18C Operator Interface Equipment Characterization

The information in this appendix of the reference ABWR DCD, including all subsections and figures, is incorporated by reference with the following departures and a supplement.

STD DEP T1 3.4-1 (Figure 18C-8)

Figure 18C-8 Overall Configuration of Operator Interface System

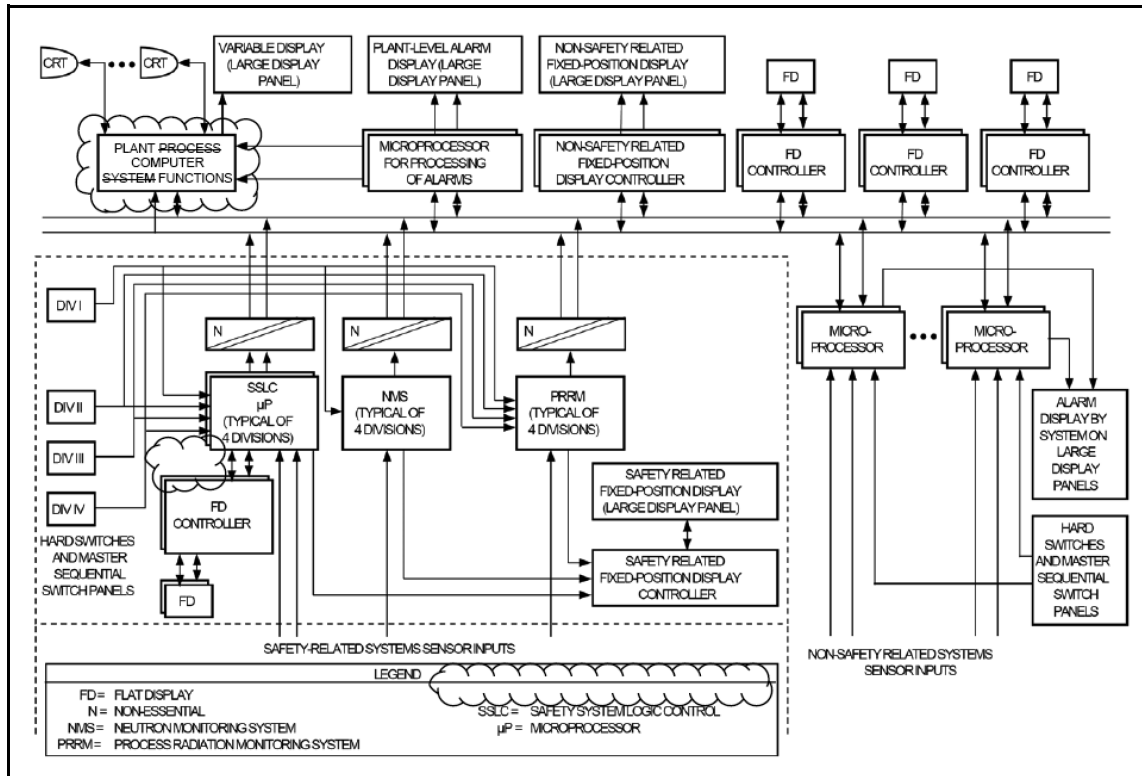
A characterization of the plant instrumentation and control systems architecture which supports the control room operator interface is illustrated in Figure 18C-8. As shown in Figure 18C-8, display and control capability for both safety-related and non-safety-related systems are driven by microprocessors which are independent of the redundant plant process computer functions. This assures the ability to safely shut down the plant in the unlikely event of computer failure. In the case of the safety-related systems, the microprocessors are divisionally dedicated and are each electrically isolated from the rest of the system.

The instrumentation and control systems architecture is not identical to the conceptual design described in Appendix 18C. The changes in the next paragraph reflect the architecture and configuration.

~~The plant wide, fiber optic Essential Multiplexing System (EMUX) provides the communications network for the system. This multiplexing system is actually a series of data acquisition and control networks, separate networks being provided for safety related and non safety related plant systems.~~ The data communication function includes both safety-related and non-safety-related communication performed by separate networks as described in Section 7.9S.
